Access Compliance Report

Public Rights-of-Way

(Curb Ramps)

Intersection ID: 15351	Main Street: BARRINGER_DR	Cross Street: CLANTON_RD	Location: NE
ADA ID: 1CF336A22FB0	Ramp Type: Perp	Initial Pass/Fail: Pass	Overall Compliance: No
Severity Score: 0			
Codes/Mitigation Info/Possible Solution		Field Measurements/Component Compliance

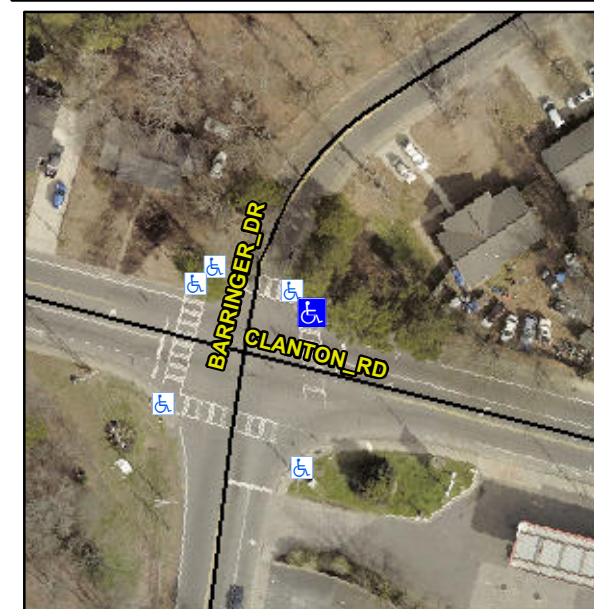
Compliance	Description	Data	Compliance	Description	Data
N/A	Ramp Length (in)	48.0	Yes	Ramp Slope (%)	7.4
Yes	Ramp Width (in)	48.0	Yes	Ramp XSlope (%)	1.8
N/A	Flare Type LT	Sloped	N/A	Flare Type RT	N/A
N/A	Flare Slope LT (%)	5.0	Yes	Flare Slope RT (%)	6.3
N/A	Flare Traversable LT?	Yes	N/A	Flare Traversable RT?	Yes
No	Landing Length (in)	24.0	Yes	DWS Provided?	Yes
Yes	Landing Width (in)	48.0	Yes	DWS Contrast?	Yes
No	Landing Slope (%)	2.4	Yes	DWS Length (in)	24.0
Yes	Landing X Slope (%)	1.4	Yes	DWS Full Width?	Yes
N/A	Landing Curb? (Y/N)	No	No	DWS Offset (in)	7.0
N/A	Shared Landing?	No			
Yes	Gutter Ponding?	No	Yes	Gutter Slope (%)	1.7
Yes	Gutter Lip Ht (in)	0.0	No	Gutter X Slope (%)	2.6
N/A	Painted X Walk1?	Yes	N/A	Painted X Walk2?	N/A
	X Walk 1 Direction	To S		X Walk 2 Direction	N/A
N/A	X Walk 1 Width (in)	108.0	N/A	X Walk 2 Width (in)	N/A
	X Walk 1 Slope (%)	6.0		X Walk 2 Slope (%)	N/A
	X Walk 1 X Slope (%)	1.1		X Walk 2 X Slope (%)	N/A

Yes	Ramp inside XWalk1?	Yes	N/A	Ramp inside XWalk2?	N/A
	Road Slope (%)	N/A	N/A	Clear Space?	Yes
	Road X Slope (%)	N/A	N/A	Clear Space to XWalk (in)	N/A
Yes	Any Obstructions?	No	Yes	Storm Grate/Utility Hazard?	No
	Obstruction Type			Storm Grate/Utility Type	
			N/A		N/A
			Yes	Surface Condition? (G/P)	Good

**Remove & Replace Entire Ramp.
Remove & Replace Gutter.**
